Access Compliance Report

Public Rights-of-Way

(Curb Ramps)

Intersection ID: 10295	Main Street: N_GRAHAM_ST	Cross Street: KESWICK_AV	Location:	E
ADA ID: 3481D7909357	Ramp Type: Perp	Initial Pass/Fail: Fail	Overall Compliance: No	Severity Score: 25

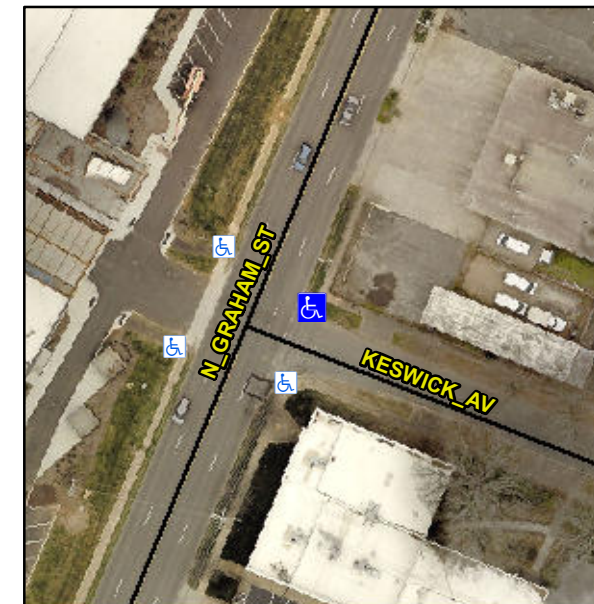
R304.2.2

Compliance	Description	Data	Compliance	Description	Data
N/A	Ramp Length (in)	87.0	No	Ramp Slope (%)	13.5
Yes	Ramp Width (in)	56.0	Yes	Ramp XSlope (%)	0.2
N/A	Flare Type LT	N/A	N/A	Flare Type RT	N/A
N/A	Flare Slope LT (%)	N/A	N/A	Flare Slope RT (%)	N/A
N/A	Flare Traversable LT?	N/A	N/A	Flare Traversable RT?	N/A
N/A	Landing Length (in)	N/A	N/A	DWS Provided?	N/A
N/A	Landing Width (in)	N/A	N/A	DWS Contrast?	N/A
N/A	Landing Slope (%)	N/A	N/A	DWS Length (in)	N/A
N/A	Landing X Slope (%)	N/A	N/A	DWS Full Width?	N/A
N/A	Landing Curb? (Y/N)	N/A	N/A	DWS Offset (in)	N/A
N/A	Shared Landing?	N/A			
N/A	Gutter Ponding?	N/A	N/A	Gutter Slope (%)	N/A
N/A	Gutter Lip Ht (in)	N/A	N/A	Gutter X Slope (%)	N/A
N/A	Painted X Walk1?	No	N/A	Painted X Walk2?	N/A
	X Walk 1 Direction	To SW		X Walk 2 Direction	N/A
N/A	X Walk 1 Width (in)	N/A	N/A	X Walk 2 Width (in)	N/A
	X Walk 1 Slope (%)	0.5		X Walk 2 Slope (%)	N/A
	X Walk 1 X Slope (%)	0.9		X Walk 2 X Slope (%)	N/A

Remove & Replace Entire Ramp.
